**Appendix L**  
**Responses to Comments**

**Final**  
**Initial Study/Mitigated Negative Declaration No. 2394**

**FIRST INDUSTRIAL LOGISTICS AT SINCLAIR STREET**  
**PROJECT**  
**DPR 22-00027**  
**(SCH No. 224020647)**

June 10, 2024

Figure 5: 40-Mile Radius from Project Site

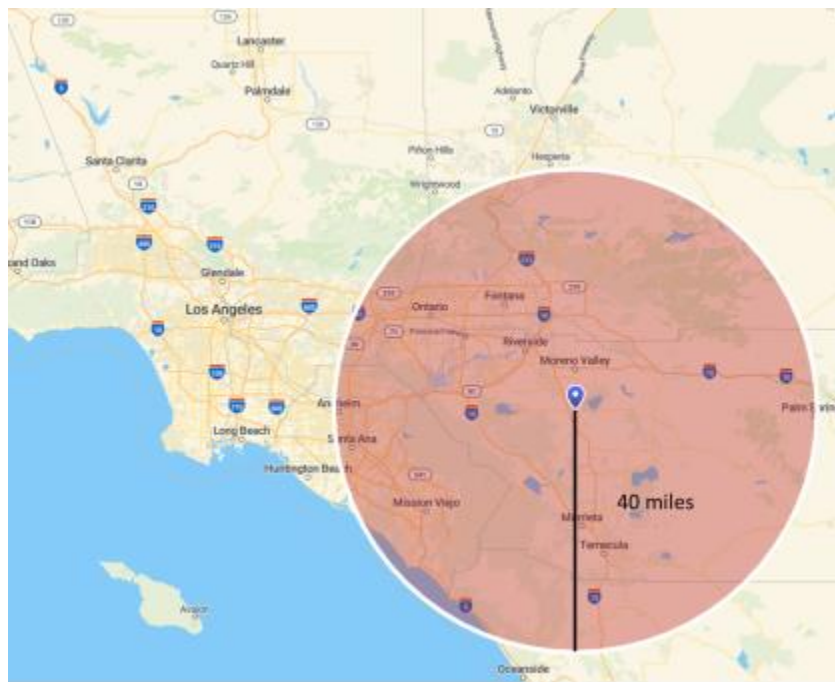
This statement does not comport with the reality of where warehoused materials will ship from in the region. The 40-mile distance is insufficient to allow vehicles to travel to the major ports in the Southern California region — Los Angeles and Long Beach (Figure 5).

The distance from the Project Site to the Ports of Los Angeles/Long Beach is approximately 80 miles, almost twice the value assumed in the air quality analysis. Using the 80-mile daily truck trip (one way – Figure 6) will nearly double the daily emissions of pollutants associated with the Project, increasing the regional burden and resulting in a potentially significant impact. The City must address the impact of this issue in an EIR.

Figure 7: Sensitive Receptors Identified In IS/MND

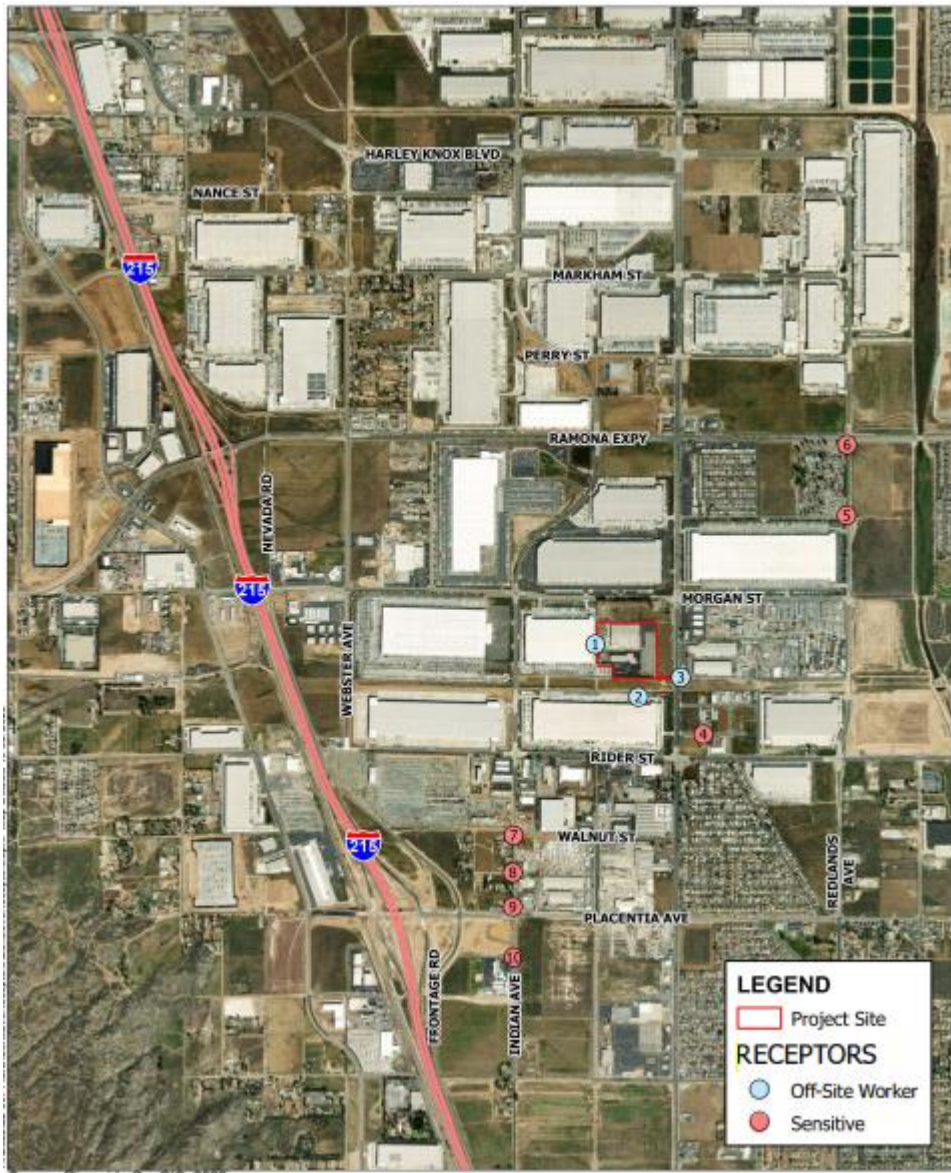
For CEQA purposes, a sensitive receptor would be a location where a sensitive individual could remain for 24-hours or longer, such as residences, hospitals, and schools (etc.). IS/MND identifies a total of 10 receptors. Six sensitive receptors and four off-site worker receptors were modeled in the Health Risk Assessment of the project (Figure 7).

The closest sensitive receptor identified, the New Creation Church, is situated approximately 985 feet (300 meters) away from the project construction site. Therefore, the project uses a receptor distance of 200 meters (656 feet)<sup>3</sup> as shown in Table F of IS/MND (Figure 8). While this receptor is acknowledged, it is evident that the omission of Park Place Mobile Home Park (Figure 9) disregards the potential health risks to a significant number of residents who reside in close proximity to the project.

The comment incorrectly infers that the Project site is located in a “densely populated area.” The Project site is mostly surrounded by other industrial uses. As shown in **Figure 2- Aerial Map** of the Initial Study/MND there are no proximal or adjacent sensitive receptors to the Project site.
